**Phoenix Subdivision
Line Segment 7208
Maricopa County, Arizona**

Bridge 149.9 Morristown, Arizona

**Final Floodplain Use Permit Report
BNSF Project Number: BF46766
Flood Control District of Maricopa County
Review Number: FCP2012072**

River Mechanics Branch Comment Resolution Matrix

PHOENIX, AZ TO WEST WILLIAMS JCT., AZ
BRIDGE NO. 149.9
OVER DRAINAGE SWALE MORRISTOWN, AZ
PROPOSED BRIDGE PLAN

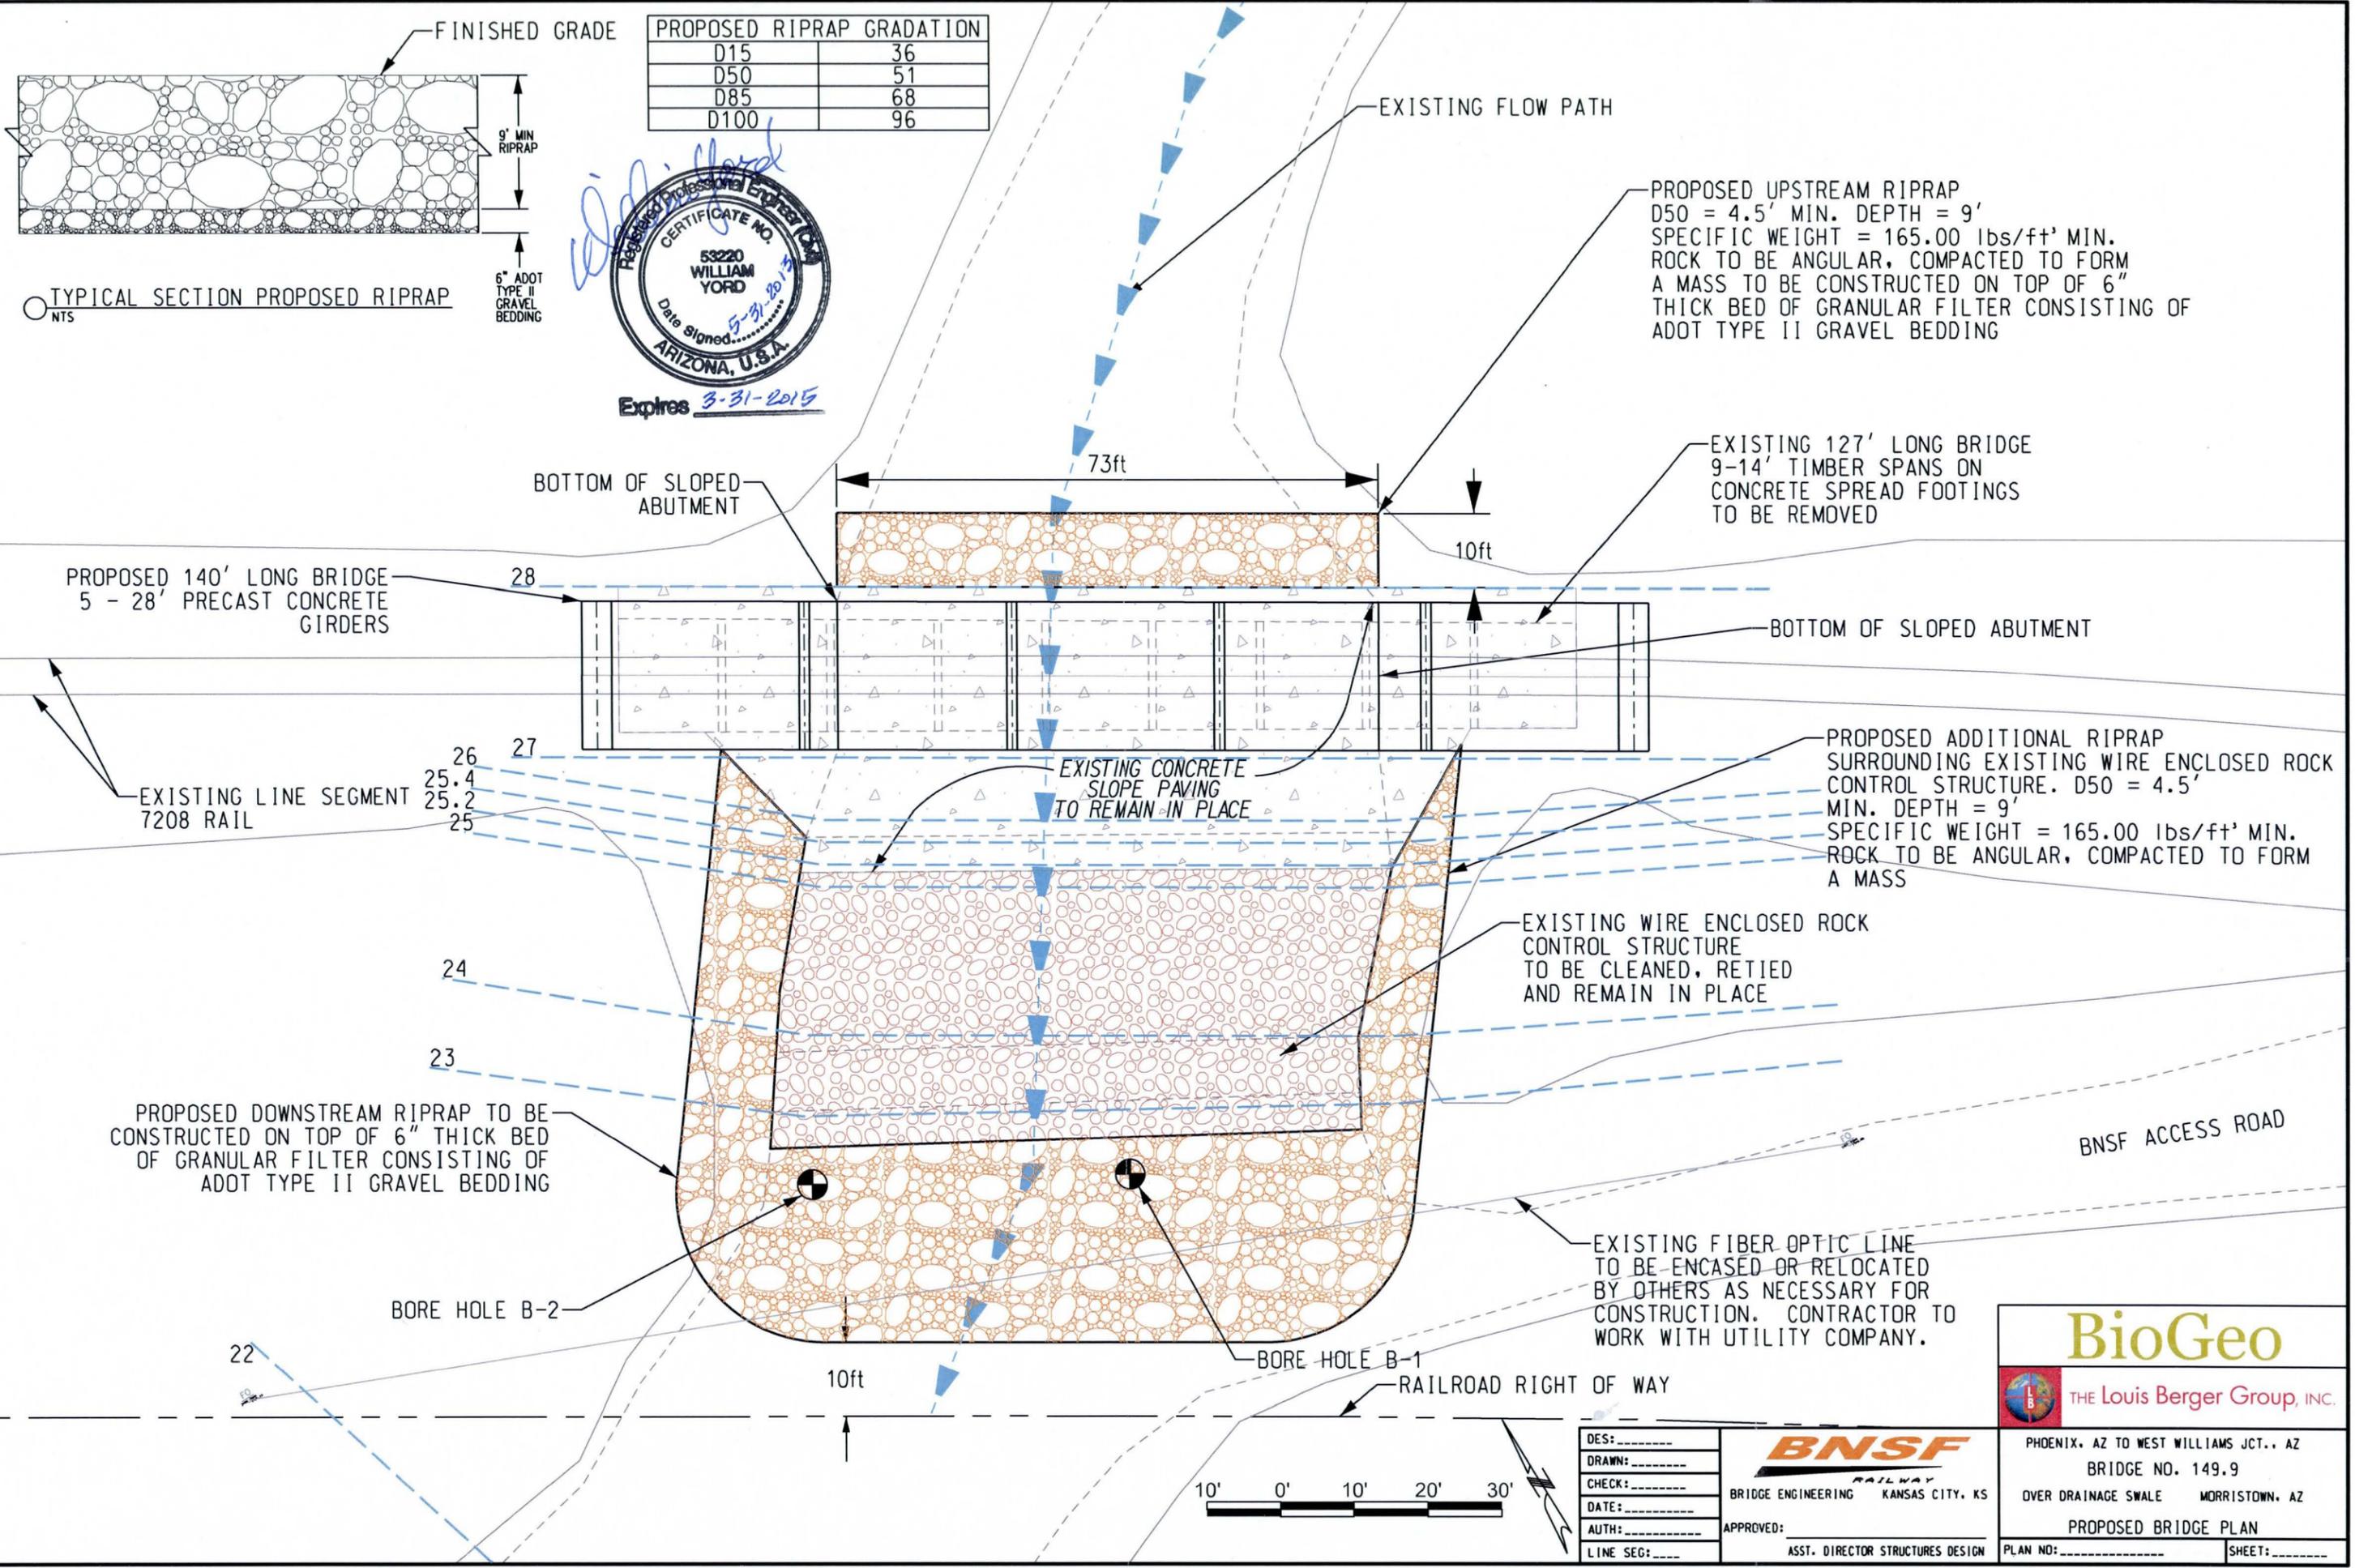
3	<p>In the pier's local scour calculation, the Consultant used an angle of attack of the flow of 0° which does not appear to be truly valid. The aerial photo below seems to show the wash is not perpendicular to the railroad.</p>	<p>An angle of attack of 30° was used for the pier local scour calculation.</p>	Comment Resolved	No Response
4	<p>The proposed D50 for the riprap expansion is 2.5' as shown in a plan sheet sealed and signed by William Yord. The riprap sizing was based on a chart claimed by the Consultant to be Form HEC-11 (USBR). However, HEC-11 is from Federal Highway Administration (publication No. FHWA-IP-89-016, March 1986) and it does not contain the chart shown in the report. In addition, the velocity based on the submitted HEC-RAS is 27.88 ft/s at cross section 23. The velocity is beyond the velocity range of the chart. It is also beyond the velocity range for the USBR D50 sizing method for riprap downstream of a stilling basin. Based on our preliminary analysis using DDMSW with "Channel Bed on a Straight Reach", the D50 is also too large to be applicable. This suggests that riprap approach may not be applicable to such high velocity. An energy dissipation structure should be installed to reduce the velocity significantly.</p>	<p>Riprap was sized using the DDMSW software at section 23 using the "Channel Bed on Straight Reach" method. The result of the calculation is a D50 of 4.48 ft., and is shown in Table 12 of Section 6.6 of the FUP Report.</p>	<p>Please Make sure that filter below the riprap will be installed. Please show it on the plans. Please also show gradation for the riprap (D100, D85, D50, and D15) on the plans.</p>	<p>Riprap gradation and filter notes were added to Proposed Bridge Plan.</p>

5	<p>The sheet for Structure Cross Section (cut at channel flow line) shows the proposed riprap expansion downstream of the existing gabion structure. But the HEC-RAS models do not correspond to this proposed channel bed profile. The HEC-RAS models show a channel invert drop. The velocity in HEC-RAS model is about 27.88 ft/s at cross-section 23. We suggest modifying the HEC-RAS model channel invert to match the proposed channel bed profile and hopefully the velocity will be less. If velocity cannot get reduced significantly, we suggest using an energy dissipation structure like a vertical concrete drop structure or the one downstream of US-60. Riprap is still required at the downstream of the energy dissipation structure. But since the velocity will be significantly reduced by the drop structure or the energy dissipation structure, smaller riprap can be used with DDMSW software (Channel Bed on Straight Reach option).</p>	<p>Cross section 23,24, and 26 were modified in the proposed model to reflect the proposed construction.</p>	<p>Although cross section 23,24, and 26 have been modified to represent the proposed construction (gabion-loose-riprap apron), the flow velocity at cross section 23 is still high (19.64 ft/s), which resulted in quite a large riprap D50 (4.48 ft). If the consultants decide to use the large riprap, we are okay. Please make sure that filter below the riprap will be installed. Please show it on the plans. Please also show gradation for the riprap (D100, D85, D50, and D15) on the plans.</p>	<p>Riprap gradation and filter notes were added to Proposed Bridge Plan.</p>
